City of Merced

Citizen Action Request Form: Traffic Committee

MERCY @ CRUIKSHANK SCHOOL

Proposed restriping to correct traffic flow conditions

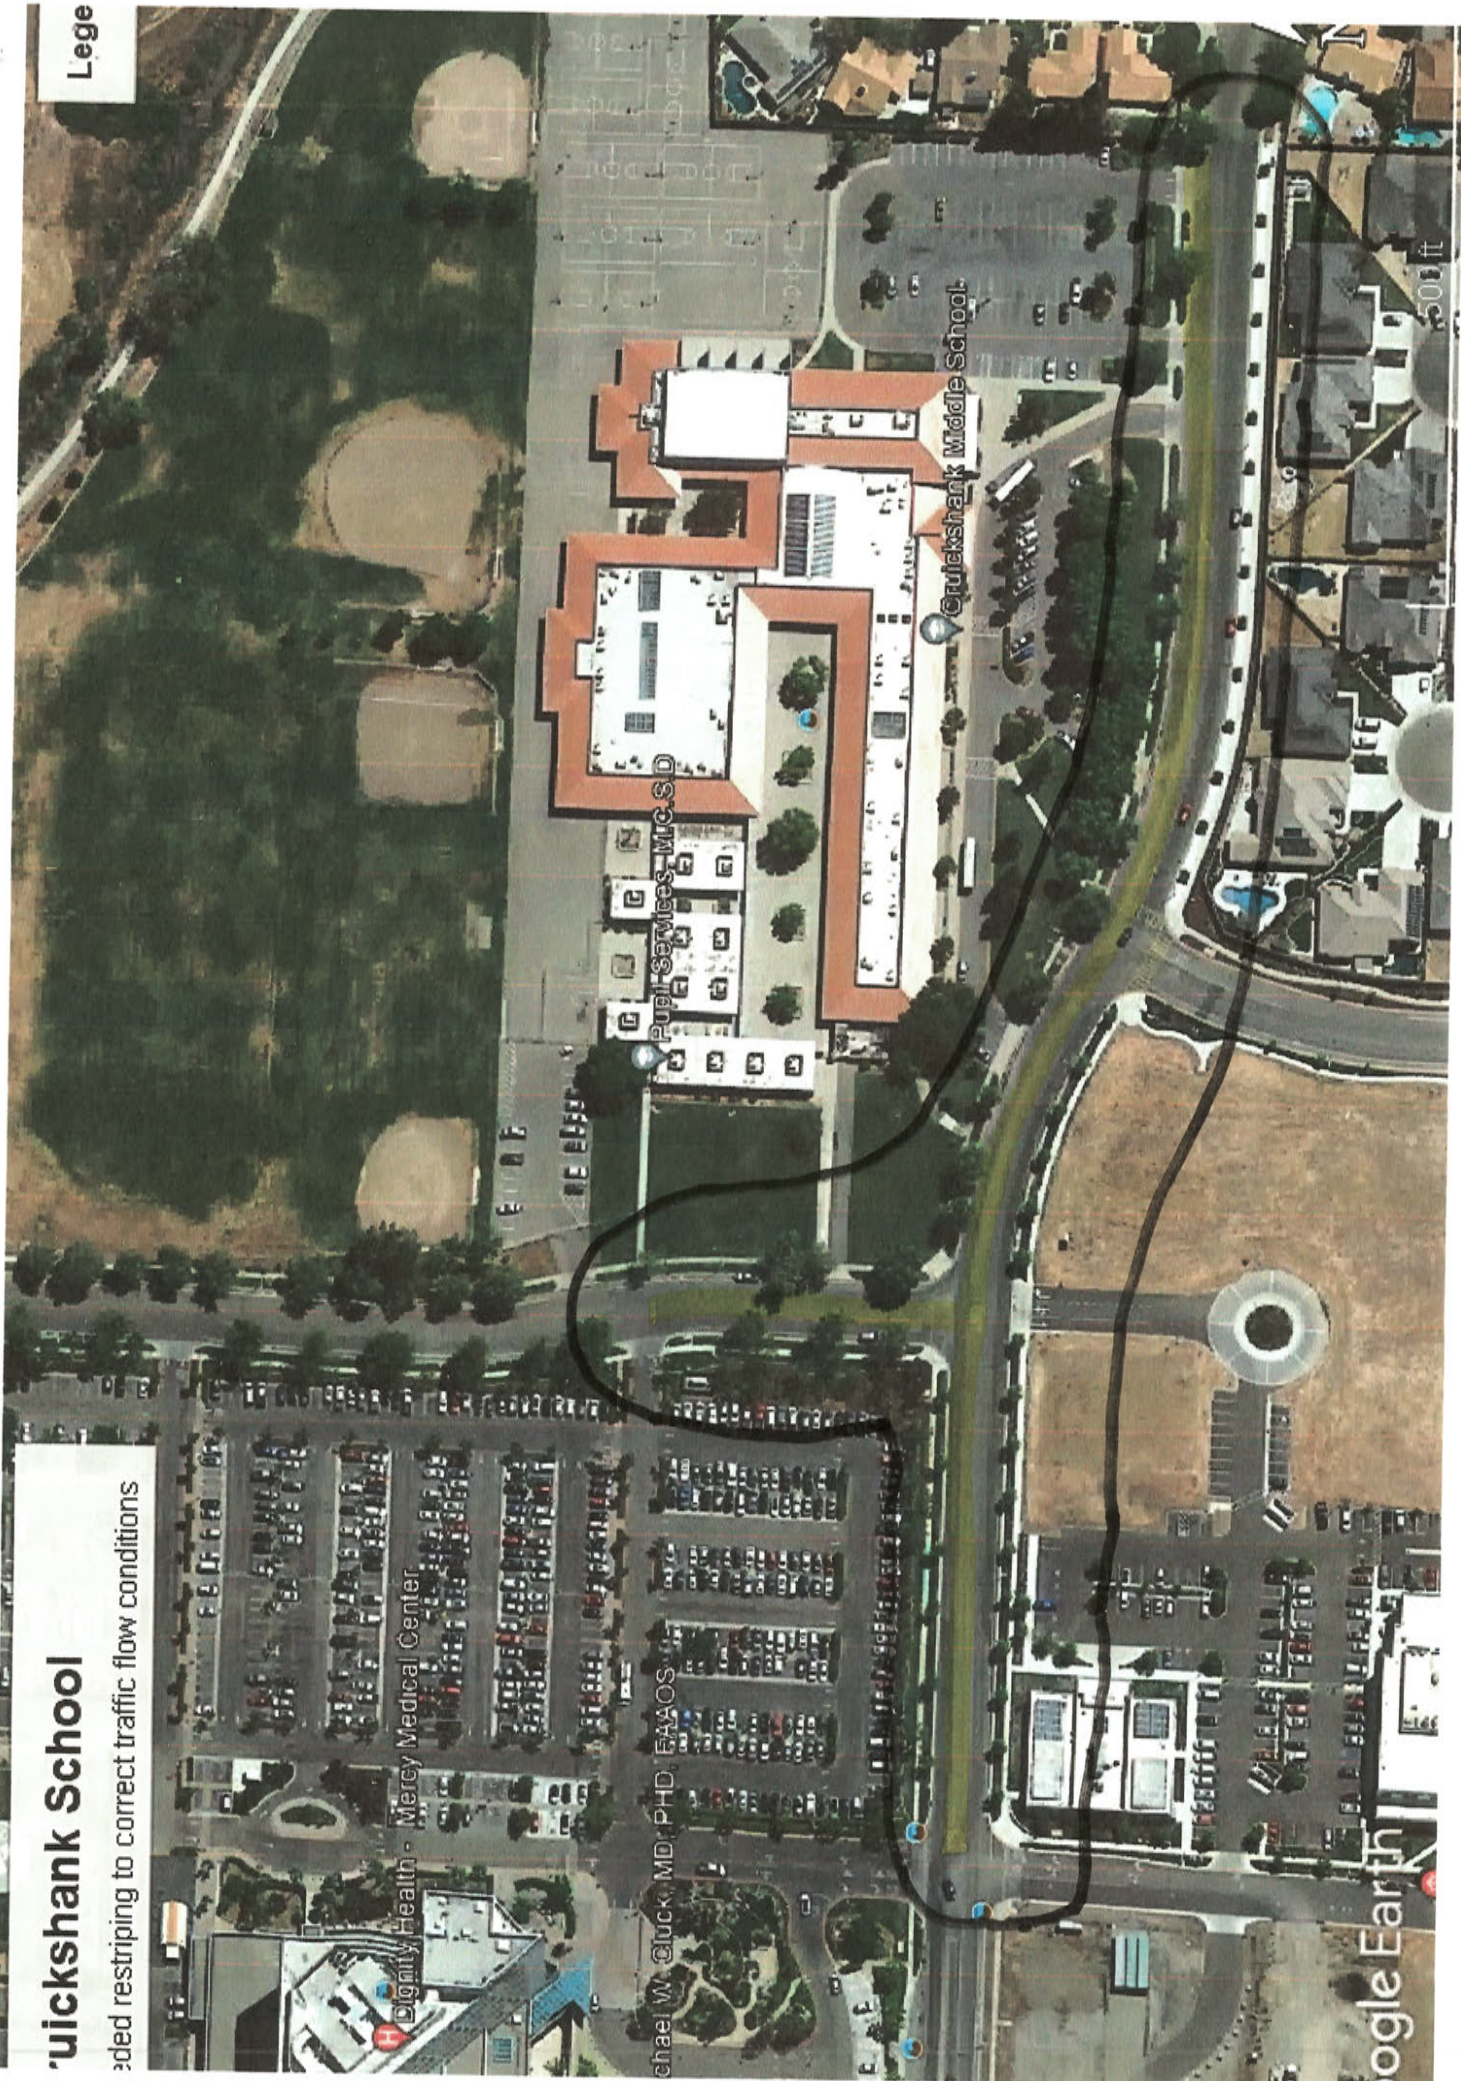
This is to bring to your attention a hazardous issue regarding street striping along the frontage of Cruickshank School, Mercy Avenue. A painted STOP in front of the school, at the intersection with Mansionette is located directly across from an old 12-foot wide painted island. This tends to hold unfamiliar drivers left of the intended travel lane, when moving in an eastward direction. Many vehicles find themselves transitioning in the intersection potentially cutting off traffic to their right. I have seen this occur many times. (You will note that this is exactly what is happening in the attached Google Earth photo).

I note also that a striped island west of Mercy's intersection with Mansonette Drive would help clarify proper lane alignment and potentially provide for a needed merge lane from Dominican Drive from the north heading eastward.

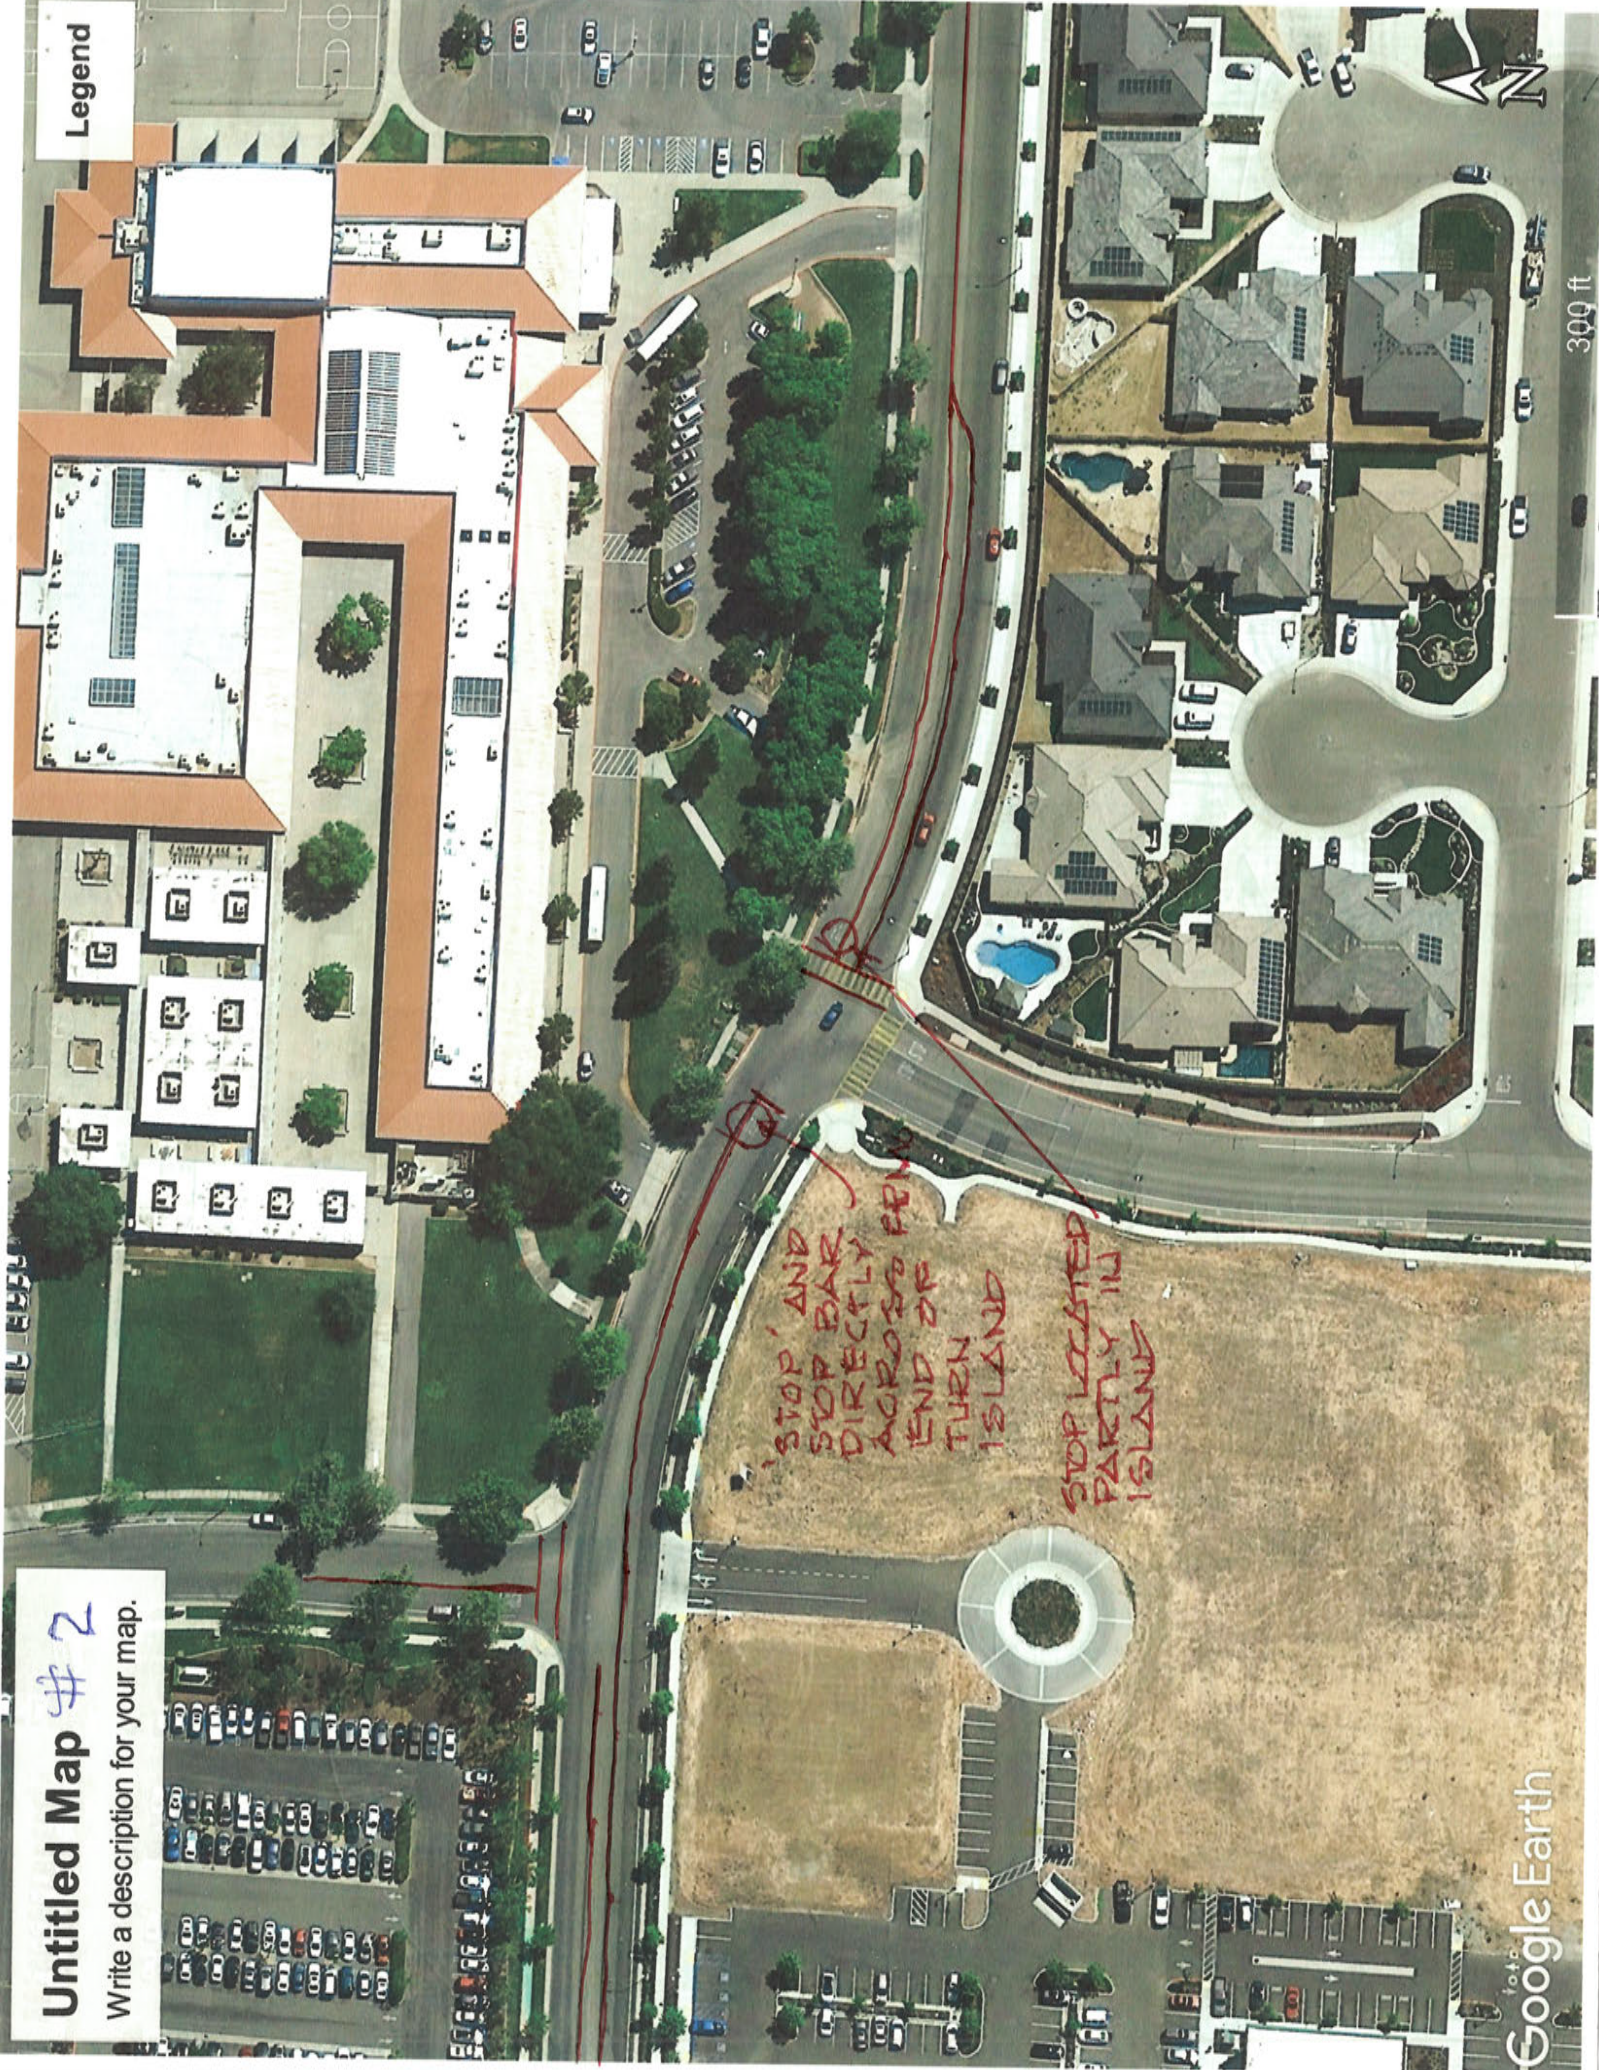
CONSIDER LEFT TURN LANE

CONSIDER MERGE LANE

MOVE STOP TO TRAVELED WAY

NOTICE CAR CHANGING LANE IN INTERSECTION

MOVE STOP OUT OF ISLAND

Cruickshank School Photos 2

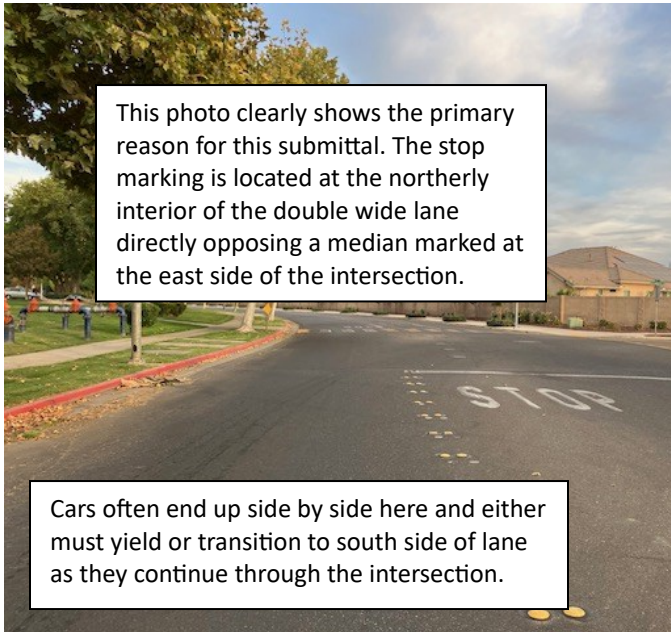
These two photos clearly show the lane delineation east of Dominican leaving a single lane width north and a double lane width south.

Here the stop is marked encroaching into the median. It should be relocated northerly.

A light turn lane at this median would be helpful for traffic turning on to Mansionette.

This photo clearly shows the primary reason for this submittal. The stop marking is located at the northerly interior of the double wide lane directly opposing a median marked at the east side of the intersection.

Cars often end up side by side here and either must yield or transition to south side of lane as they continue through the intersection.

Cruickshank School Photos 1

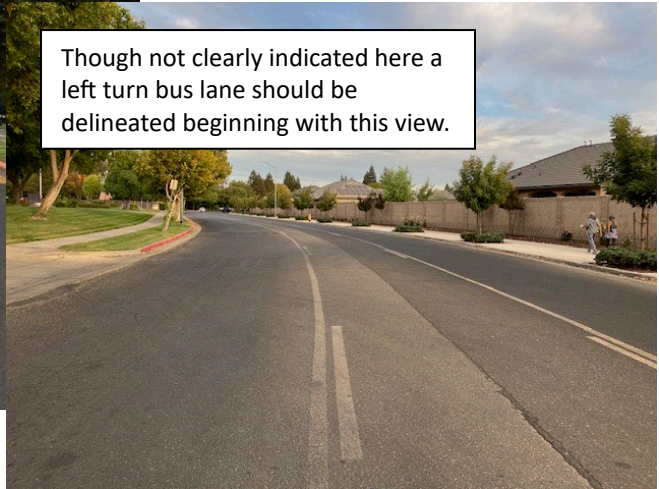
Turn lane at the south entrance to the hospital

Note full width turn lane and arrow

These two photos show what remains of 12 ft. wide median lanes. They are not currently marked for that use

The area in the foreground fronts the hospital. Restriping here would help traffic flow.

West of Dominican on Mercy Dr. you can see faded markings for a median. Perhaps it should be remarked with stacked turn lane onto Dominican

East of Dominican there is one lane marked to the north side of the street leaving one double wide lane on the south side headed east

This distance to Mansionette should contain a merge lane headed east; or at least a median as will be seen on the next page
